Correction on timing chart ($f_v = 60 \text{ Hz}$)

TIMING CHART (fv = 60Hz)

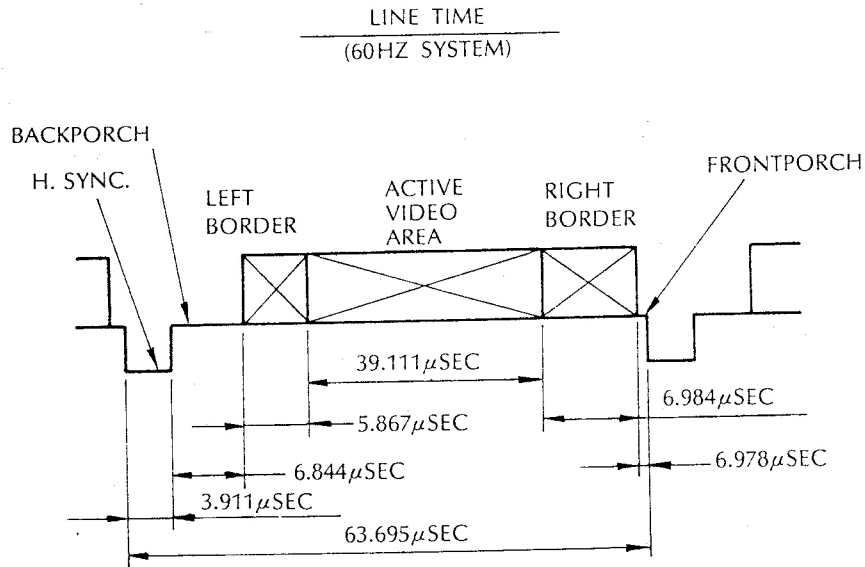
On the horizontal part, please note that the timing between the right border and the frontporch is 0,978 usec and not 6,978 usec as written.
